Champions Quarry Expansion

MODIFICATION 2 RESPONSE TO SUBMISSIONS 2016 (APRIL 2016)

CHAMPIONS QUARRY RESPONSE TO SUBMISSIONS (APRIL 2016)

Annexure E – Surveyors plan of biodiversity offset areas dated 24 June 2014 noting the areas and revised plan SP15109-SP2 (Item 7).

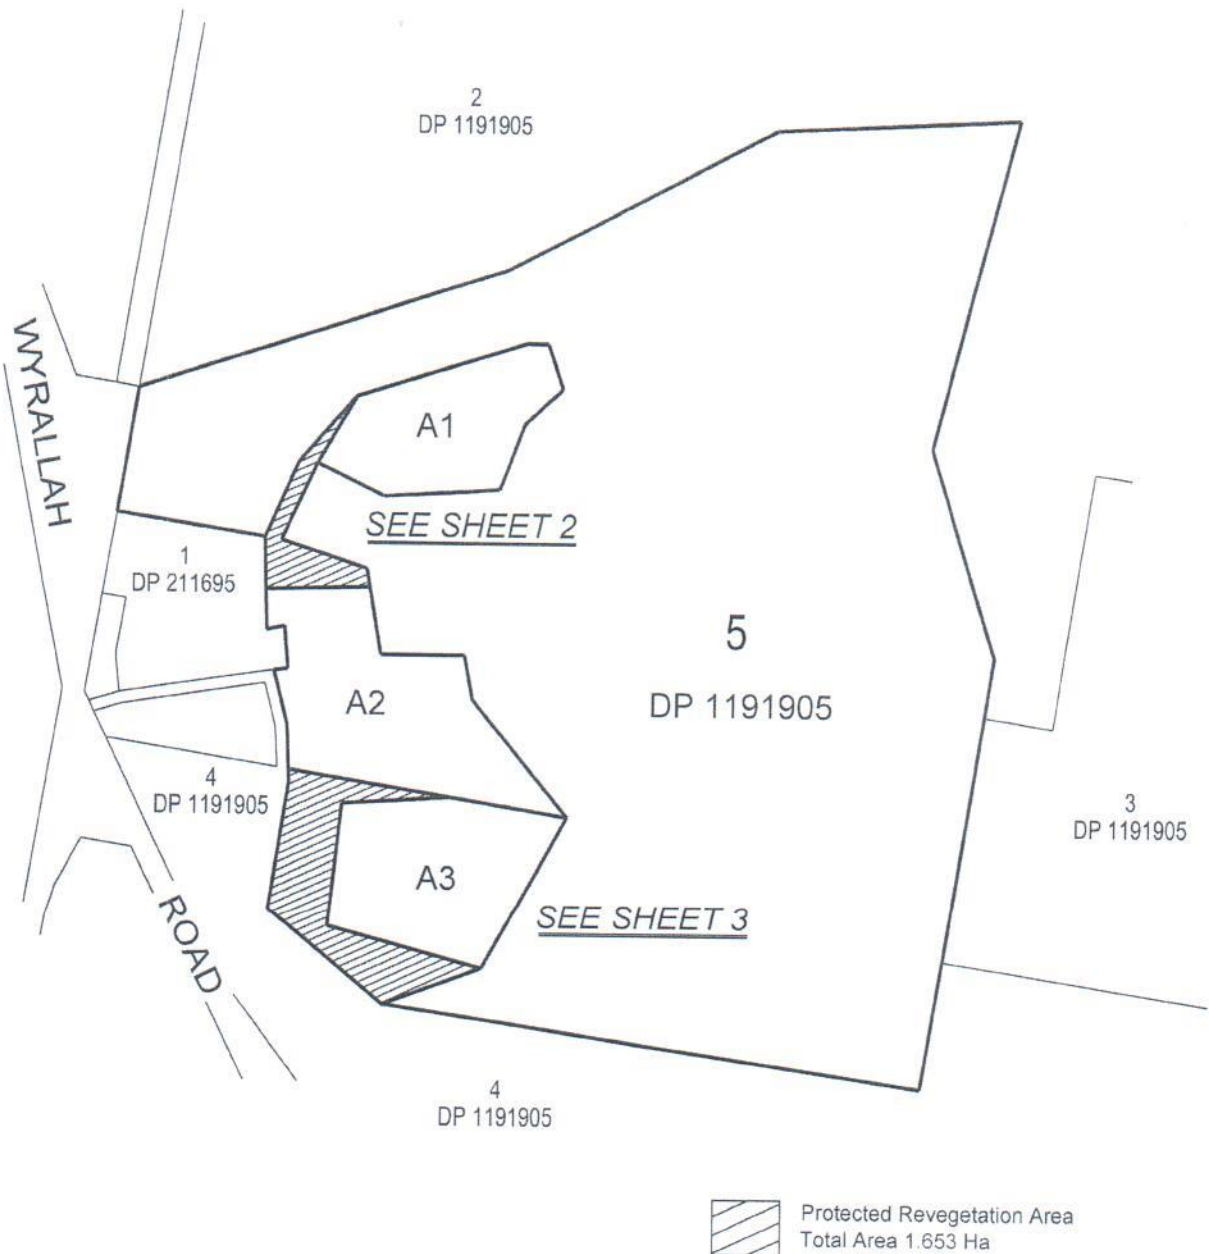
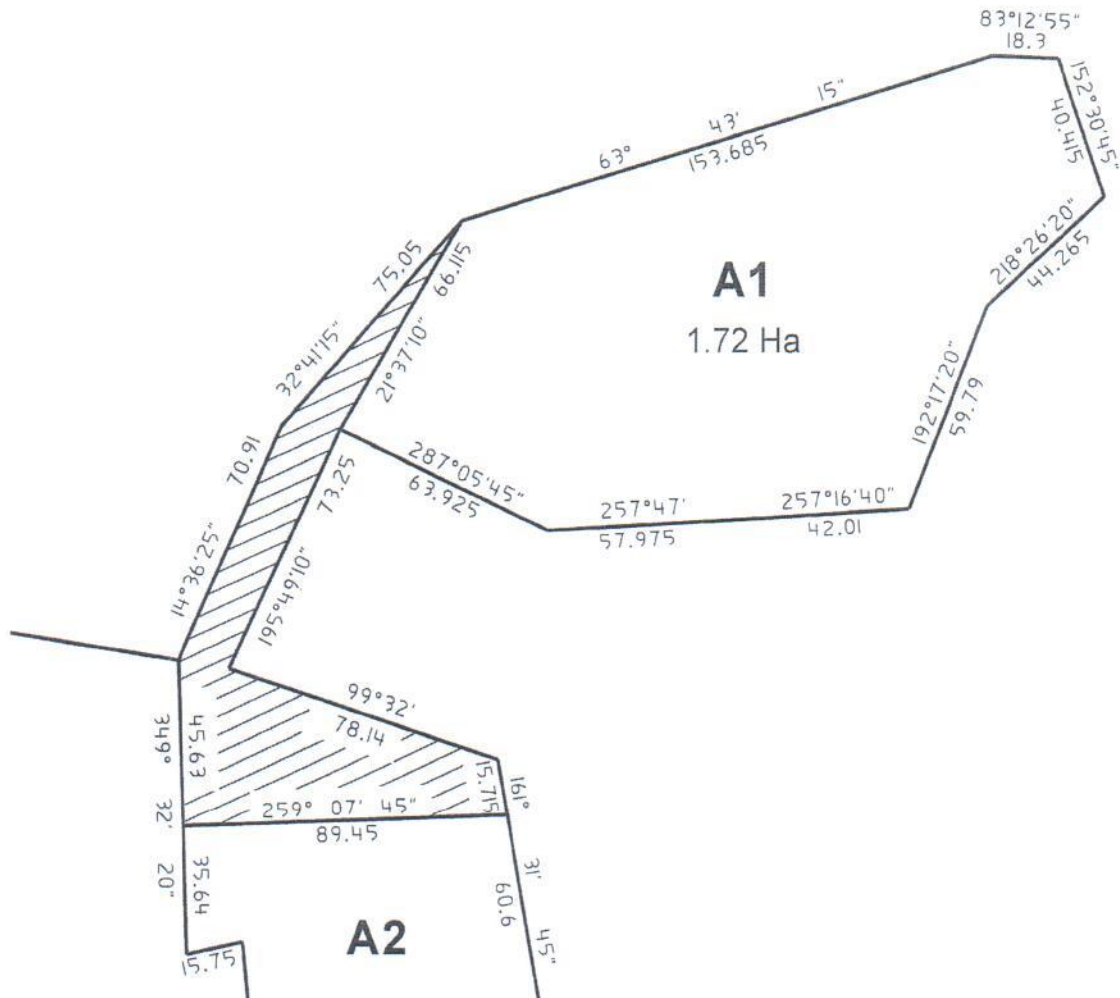
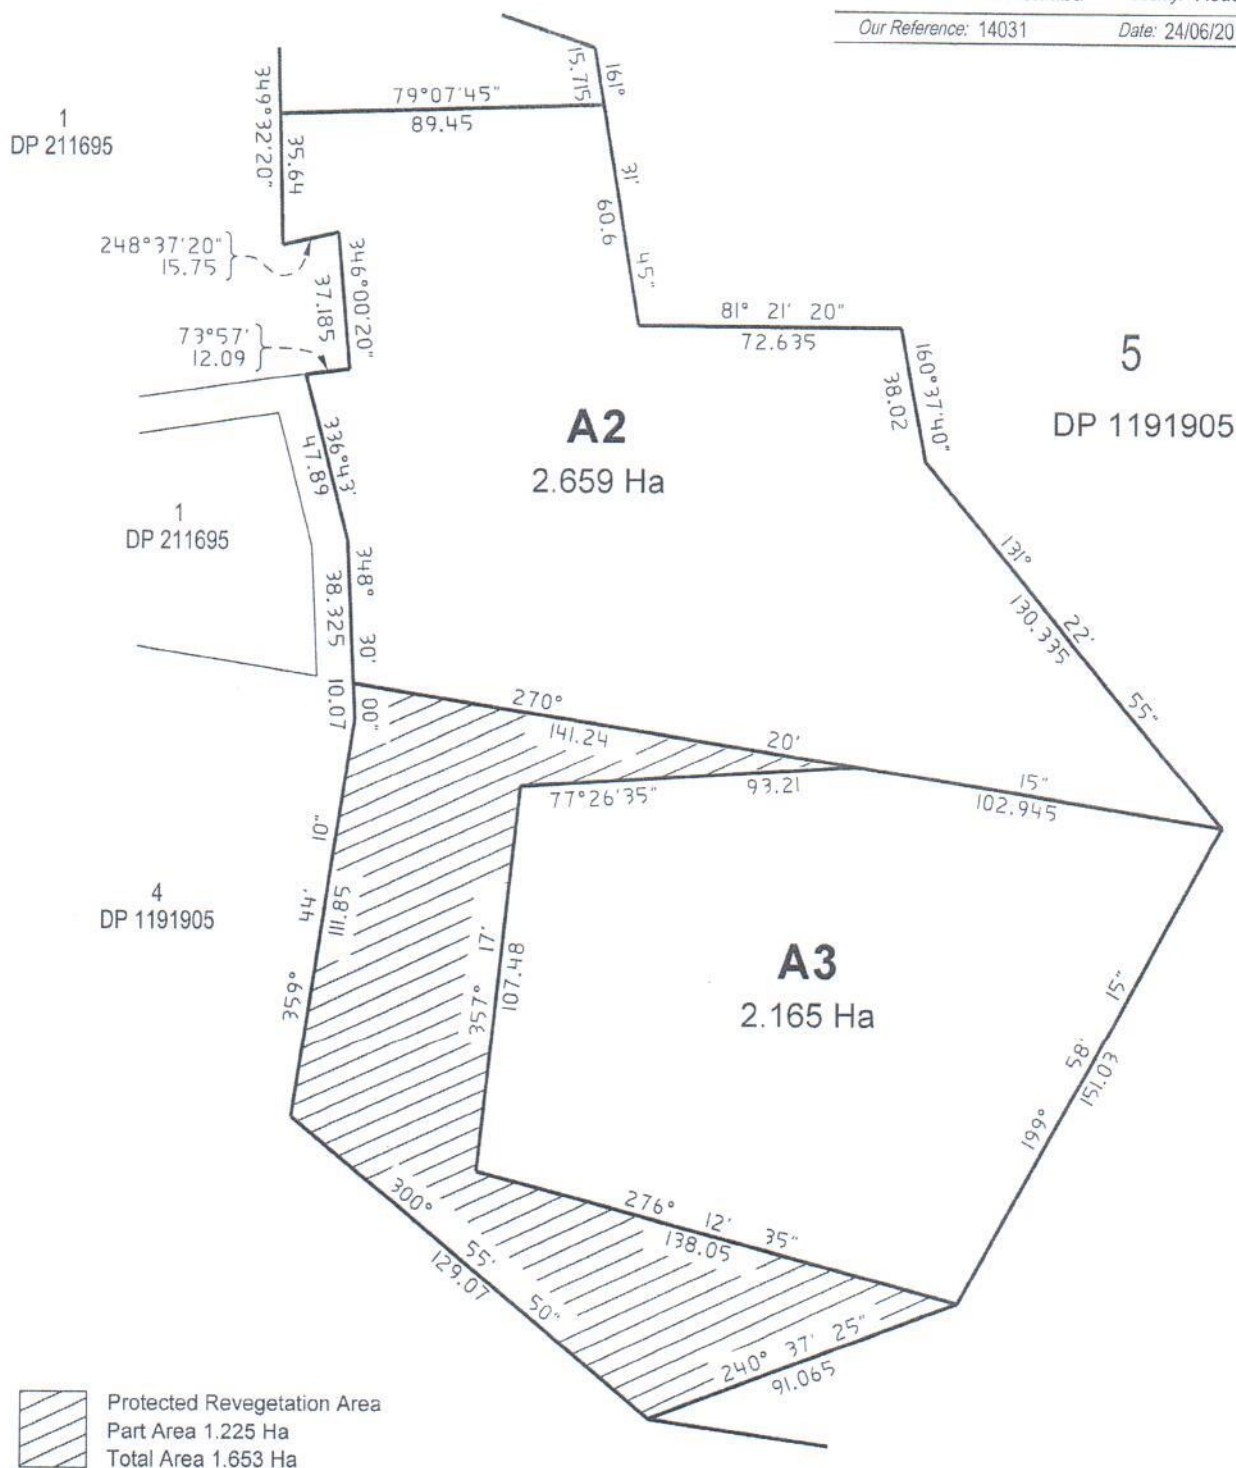
6.	Construction of a dam and other earthworks is in proximity to biodiversity offset areas. Review of the aerial photograph shows a dam has been constructed between the biodiversity offset areas 1 and 2 in a location that appears to be the currently approved location for one of the protected revegetation areas.

7.	Demonstrate, through noting on a figure of the size in hectares, that the area of the revised biodiversity offsets and protected revegetation area satisfies the minimum size requirements specified in in Condition 40, Table 7.

Please refer to Annexure E being the Surveyors plan of biodiversity offset areas dated 24 June 2014 noting the areas and revised plan SP15109-SP2 with the areas. Please refer to Annexure F being the revised Figure 9 in the Project Approval noting the total areas of the biodiversity offset areas.	Table 7 - Project Approval		Proposed Area	Area Offset	Minimum Size (ha)	Minimum Size (ha)	Area 1	1.71 ha	1.72 ha	Area 2	2.56 ha	2.659 ha	Area 3	2.14 ha	2.165 ha	Protected Revegetation Area	1.5 ha	1.653 ha	TOTAL	7.91 ha	8.197 ha
Table 7 - Project Approval		Proposed Area																					
Area Offset	Minimum Size (ha)	Minimum Size (ha)																					
Area 1	1.71 ha	1.72 ha																					
Area 2	2.56 ha	2.659 ha																					
Area 3	2.14 ha	2.165 ha																					
Protected Revegetation Area	1.5 ha	1.653 ha																					
TOTAL	7.91 ha	8.197 ha

We note that the specified Protected Revegetation Area should have a minimum area of 1.5 Ha under Condition No. 40 of the Project Approval. The total area provided for the Protected Revegetation Area by survey is 1.653 Ha. There is an additional 0.153 Ha made available, of which 0.01 Ha is comprised in the dam encroachment.
